Access Compliance Report

Public Rights-of-Way

(Curb Ramps)

Intersection ID: 13531	Main Street: REMOUNT_RD	Cross Street: WEST_BV	Location: SW
ADA ID: 07F0004BF84C	Ramp Type: PerpDiag	Initial Pass/Fail: Pass	Overall Compliance: No
		Severity Score: 10

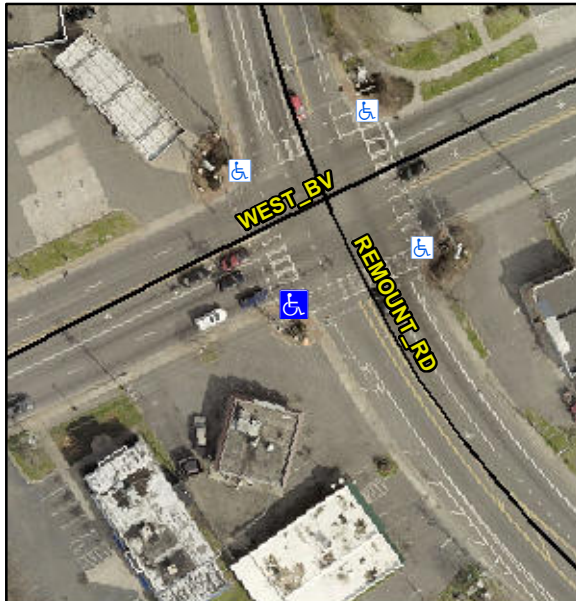
Not Found, R304.2.2-Perp, R304.3.2-Para, R304.5.3, R305

Compliance	Description	Data	Compliance	Description	Data
N/A	Ramp Length (in)	64.0	Yes	Ramp Slope (%)	5.4
Yes	Ramp Width (in)	63.5	Yes	Ramp XSlope (%)	1.4
N/A	Flare Type LT	Sloped	N/A	Flare Type RT	N/A
N/A	Flare Slope LT (%)	1.6	Yes	Flare Slope RT (%)	4.4
N/A	Flare Traversable LT?	Yes	N/A	Flare Traversable RT?	Yes
Yes	Landing Length (in)	72.0	No	DWS Provided?	No
Yes	Landing Width (in)	63.5	N/A	DWS Contrast?	No
No	Landing Slope (%)	2.2	N/A	DWS Length (in)	N/A
No	Landing X Slope (%)	3.5	N/A	DWS Full Width?	No
N/A	Landing Curb? (Y/N)	No	N/A	DWS Offset (in)	N/A
N/A	Shared Landing?	No			
Yes	Gutter Ponding?	No	Yes	Gutter Slope (%)	3.2
Yes	Gutter Lip Ht (in)	0.0	Yes	Gutter X Slope (%)	1.6
N/A	Painted X Walk1?	Yes	N/A	Painted X Walk2?	Yes
	X Walk 1 Direction	To E		X Walk 2 Direction	To N
N/A	X Walk 1 Width (in)	111.0	N/A	X Walk 2 Width (in)	110.0
	X Walk 1 Slope (%)	1.1		X Walk 2 Slope (%)	3.1
	X Walk 1 X Slope (%)	2.6		X Walk 2 X Slope (%)	1.6

Remove & Replace Curb Ramp With Two New Directional Ramps or Equivalent.
